# **DEVELOPMENT REVIEW BOARD REPORT**

ACTION	
Trailwest 11-DR-2019	
Location:	3213 North Hayden Road
Request:	Request by owner for approval of the site plan, landscape plan, and building elevations for the renovation of an existing shopping center, with approximately 14,603 square feet of building area, all on a 1.8-acre site.

# **Stipulations for the Development Review Board Application:** Trailwest Case Number: 11-DR-2019

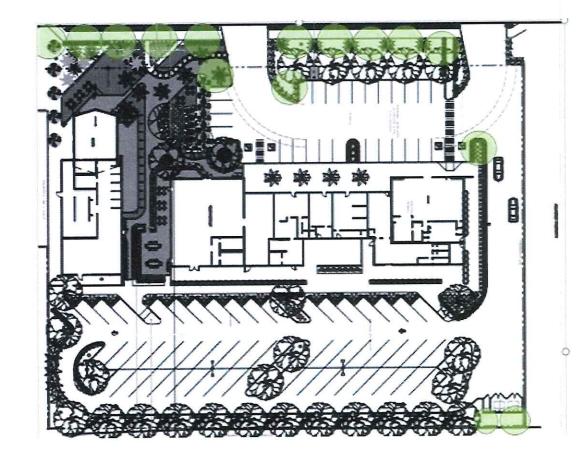
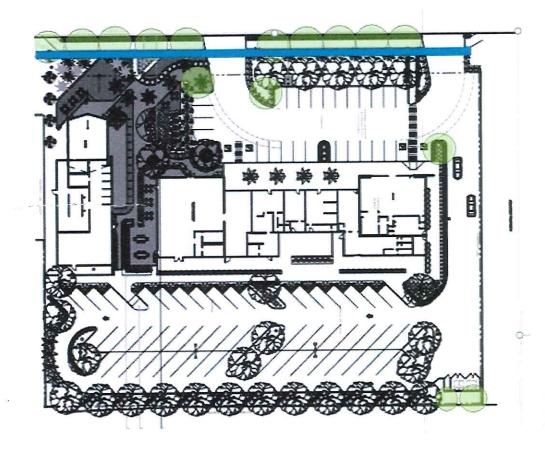
2<sup>nd</sup>, I really wish there were more shade trees along Hayden Road. The "new" car wash to the north is bare, as are many of the newer developments. I like the proposed landscape plan, but was hoping the trees at the street front could either be pushed further west, to provide shade on the existing sidewalk, or, if the sidewalk is being replaced, that the sidewalk shift east, allowing the trees room to grow on the west side, providing greater shade for pedestrians. As we add density to this area, we need to recognize the use of sidewalks as a mode of transportation, ideally separated from the street and shaded.

3<sup>rd</sup>, I have provided a diagram showing where additional trees would be helpful for shade.

4<sup>th</sup>, The landscape palette shows a lot of tree species, but the plan shows almost all Ash. Can there be some more diversity as shown in the palette?
